NOTICE OF PROPOSED AMENDMENT (NPA) No 2007-17

amending Decision No 2003/15/RM of the Executive Director of the European
Aviation Safety Agency of 14 November 2003
on
certification specifications, including airworthiness codes and acceptable means of
compliance for small rotorcraft (« CS-27 »)

amending Decision No 2003/16/RM of the Executive Director of the European
Aviation Safety Agency of 14 November 2003
on
certification specifications for large rotorcraft (« CS-29 »)

amending Decision No 2003/17/RM of the Executive Director of the European
Aviation Safety Agency of 14 November 2003
on
certification specifications, including airworthiness codes and acceptable means of
compliance for very light rotorcraft (« CS-VLR »)

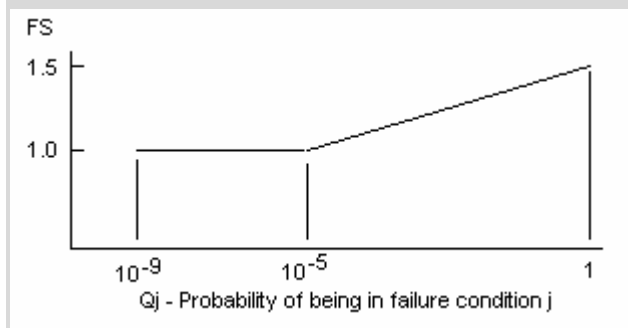
Maximum displacement of the directional control, except as limited by pilot effort (CS 27.397(a)), is required for the conditions cited in the certification specification. In the load evaluation credit may be taken for consideration of the effects of control system limiting devices.

However, the probability of failure or malfunction of these system(s) should also be considered and if it is shown not to be extremely improbable then further load conditions with the system in the failed state should be evaluated. This evaluation may include Flight Manual Limitations, if failure of the system is reliably indicated to the crew.

A yaw limiting device is a typical example of a system whose failed condition should be investigated in the assessment of the loads requested by CS 27.351.

An acceptable methodology to investigate the effects of all system failures not shown to be extremely improbable on the loading conditions of CS 27.351 is as follows:

a) With the system in the failed state and considering any appropriate reconfiguration and flight limitations, it should be shown that the rotorcraft structure can withstand without failure the loading conditions of CS 27.351, when the manoeuvre is performed in accordance with the provisions of the this AMC.

b) The factor of safety to apply to the above specified loading conditions to comply with CS 27.305 is defined in the figure below.

$$Q_j = (T_j)(P_j)$$

Note: If P_j is greater than 1×10^{-3} per flight hour then a 1.5 factor of safety should be applied to all limit load conditions evaluated for the system failure under consideration.

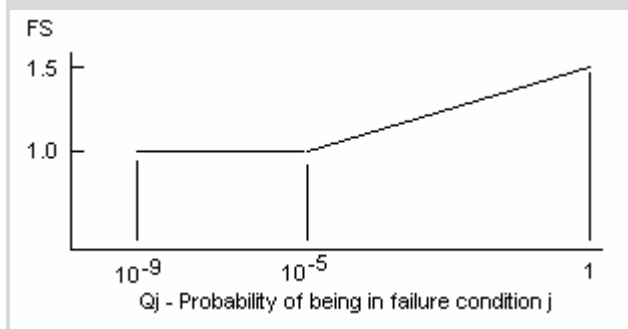
Maximum displacement of the directional control, except as limited by pilot effort (CS 29.397(a)), is required for the conditions cited in the certification specification. In the load evaluation credit may be taken for consideration of the effects of control system limiting devices.

However, the probability of failure or malfunction of these system(s) should also be considered and if it is shown not to be extremely improbable then further load conditions with the system in the failed state should be evaluated. This evaluation may include Flight Manual Limitations, if failure of the system is reliably indicated to the crew.

A yaw limiting device is a typical example of a system whose failed condition should be investigated in the assessment of the loads requested by CS 29.351.

An acceptable methodology to investigate the effects of all system failures not shown to be extremely improbable on the loading conditions of CS 29.351 is as follows:

a) With the system in the failed state and considering any appropriate reconfiguration and flight limitations, it should be shown that the rotorcraft structure can withstand without failure the loading conditions of CS 29.351, when the manoeuvre is performed in accordance with the provisions of the this AMC.

b) The factor of safety to apply to the above specified loading conditions to comply with CS 29.305 is defined in the figure below.

$$Q_j = (T_j)(P_j)$$

Note: If P_j is greater than 1×10^{-3} per flight hour then a 1.5 factor of safety should be applied to all limit load conditions evaluated for the system failure under consideration.
